Subject: WATER PUMP COOLANT LEAK	Bulletin No: 01-016/16
	Last Issued: 08/26/2016

This bulletin supersedes the previously issued bulletin(s) listed below: The changes are noted in Red beside the change bars.

Previously issued TSBs:	Date issued:
01-004/09	02/03/2009

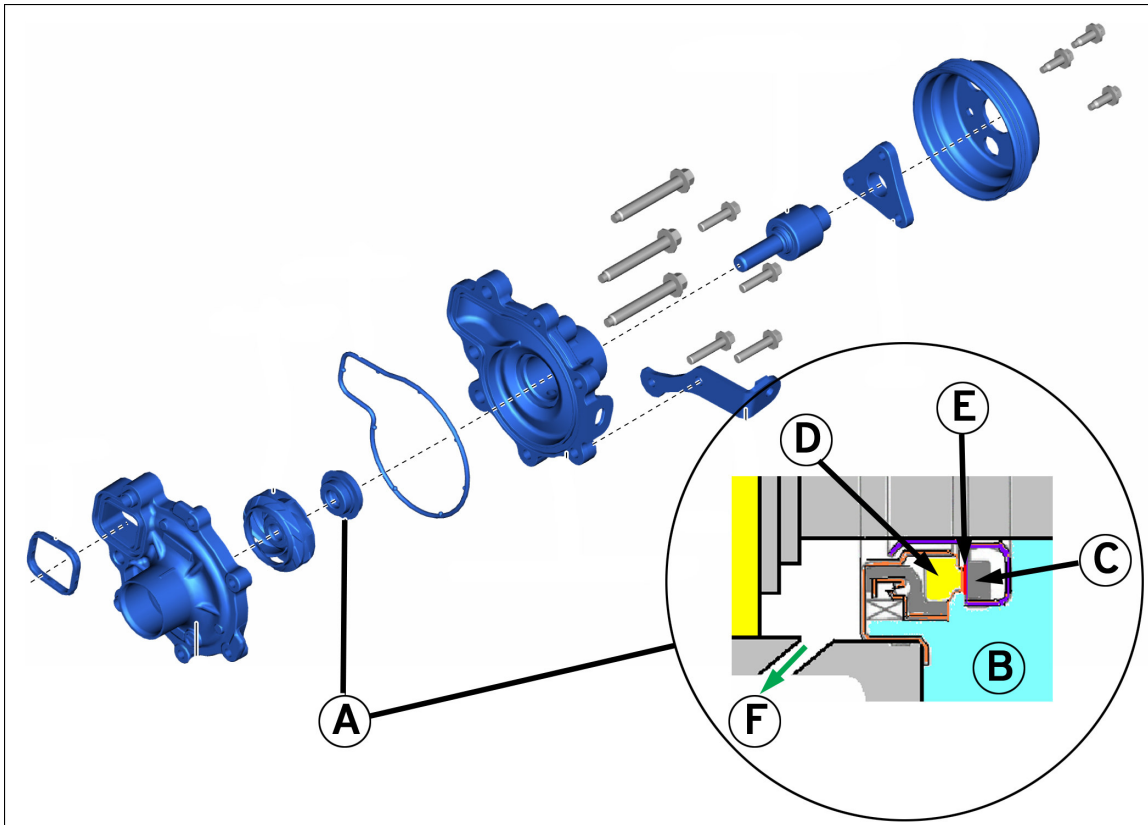
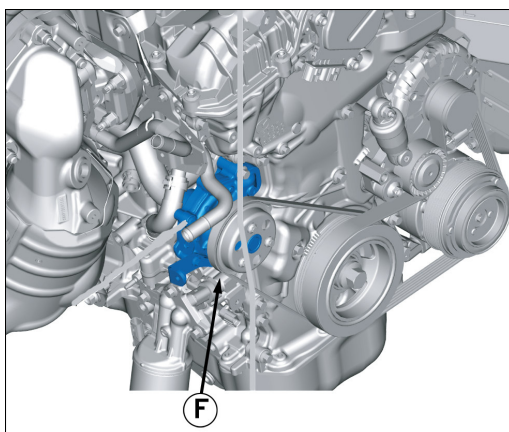
A mechanical seal (A) is used for the water pump. This mechanical seal can seal coolant (B) by sliding a mating ring (C) against a seal ring (D). When the sliding surface temperature of the mechanical seal is more than 248 °F (120 °C) while driving, a small amount of steam (E) is leaked and bleeds through the bleeding hole (F). After drying, the steam leaves a green coolant deposit near the water pump bleed hole (F). This is a normal condition and does not require water pump replacement. The water pump should only be replaced if there is an accumulation of crystallized coolant near the bleed hole.

Water Pump Samples:

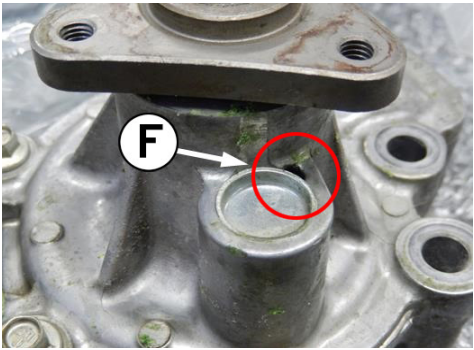
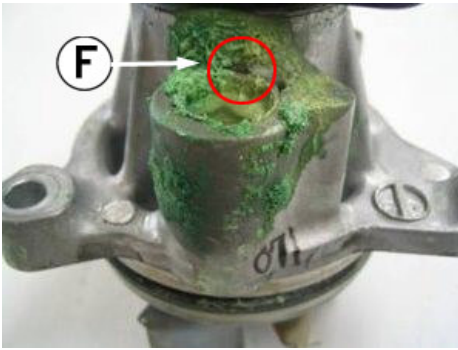
Dried coolant steam shows as green-color deposit at bleed hole.

<p>GOOD No accumulation of crystallized coolant. DO NOT replace the water pump.</p>	<p>NG Accumulation of crystallized coolant near the bleed hole (F). Replace the water pump.</p>
